Town of Caledon IFRQ #23-142 Peer Review of the Transportation Impact Study and Haul Route Assessment

Date: Monday, November 25, 2024

Project: Town of Caledon IFRQ #23-142 – Peer Review of the Transportation Impact Study and Haul Route Assessment for Proposed Official Plan Amendment (POPA 2022-0006) and Zoning By-law Amendment (RZ 2022-0010) – CBM Caledon Quarry

Subject: Peer Review of the Transportation Impact Study and Haul Route Assessment – CBM Caledon Quarry

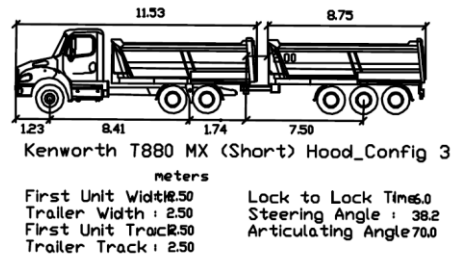
Figure 9-1 does not show the existing edge of pavement and should be revised to include the existing and future edge of pavement. The graphic should also indicate the required widening through the section of the roadway where the access is proposed. If the entrance location is shifted west, then widening should still be identified on the drawing.

The swept path analysis contained in Appendix H was undertaken using a “truck and pony trailer” and “dump-truck”. It would be more appropriate to use an articulated dump truck that accurately reflects the largest design vehicles anticipated to enter the site. The larger design vehicle should be used to determine the curb radius requirements. An example articulated dump truck is the “T880 MX (Short) Hood_Config 3” which is contained in the AutoTURN library and is presented below:

10. The swept path analysis should be revisited with a design vehicle that is a more accurate representation of the largest vehicles which will access the site. The truck with pony trailer may only be used if it is demonstrated that the swept path would be equal to the articulated dump trucks or the other largest design vehicles which will enter the site. In our experience, there are dump trucks with trailers within AutoTurn software which should be preferentially used for the swept path analysis in support of the entrance design.
